BCA ASSESSMENT REPORT

**Yiribana Logistics Estate, Kemps Creek
Warehouse 1 & 3 (Stage 1)**

**Prepared For:
The GPT Group**

Revision 2

Figure 1 – Warehouse 1 Perimeter Vehicular Access per BCA C2.4.

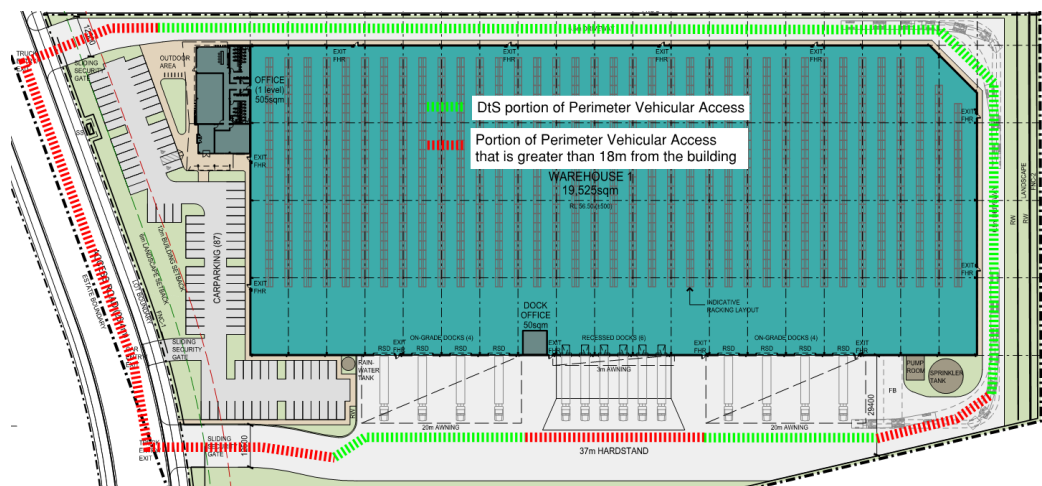
Comments: The proposed Warehouse buildings do not comply with the provisions of C2.4 and thus the following non-compliance issues are required to be addressed as a Performance Solution by the Fire Engineer to demonstrate compliance with Performance Requirement CP9:

- + *Perimeter Vehicular Access is greater than 18m from the external walls along the western side of the building, along the southern side of the warehouse at the recessed docks and in the south-eastern corner near the sprinkler tank & pump room – refer below mark-up:*

Note 1: Any proposed sliding gates are to achieve no less than 6m unobstructed width or the reduced width will need to be included in the above Performance Solution.

Note 2: The driveways providing vehicular perimeter access must be designed with adequate loading capacities to withstand a fire truck and the gradients of any ramps and swept paths should take into consideration the requirements of the FRNSW Fire Safety Guideline – Access for Fire Brigade Vehicles and Firefighters.

Figure 2 – Warehouse 3 Perimeter Vehicular Access per BCA C2.4.

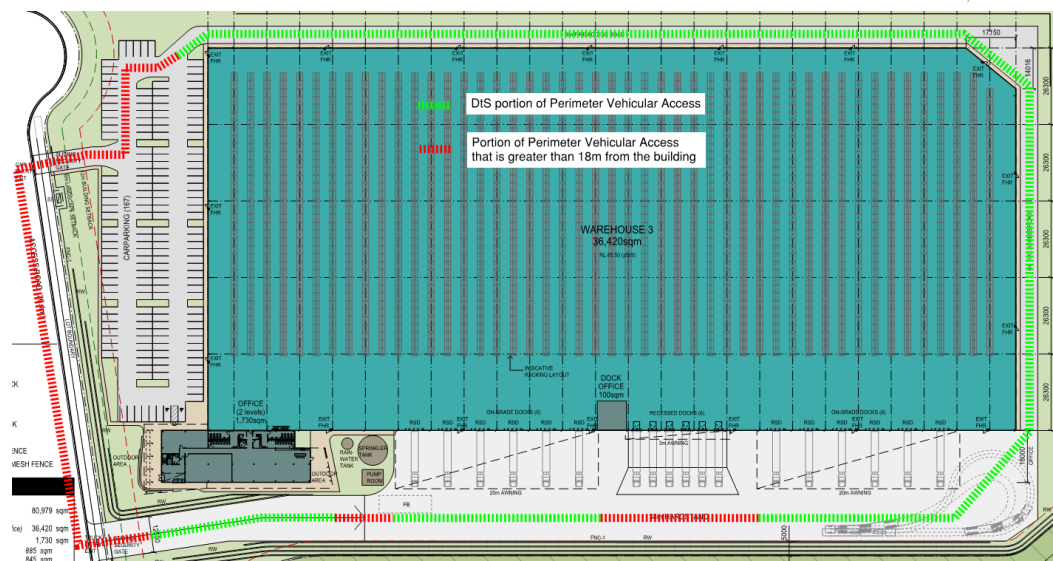
- + *Perimeter Vehicular Access is greater than 18m from the external walls along the western side of the building, along the southern side of the warehouse at the recessed docks and near the sprinkler tank & pump room – refer below mark-up:*
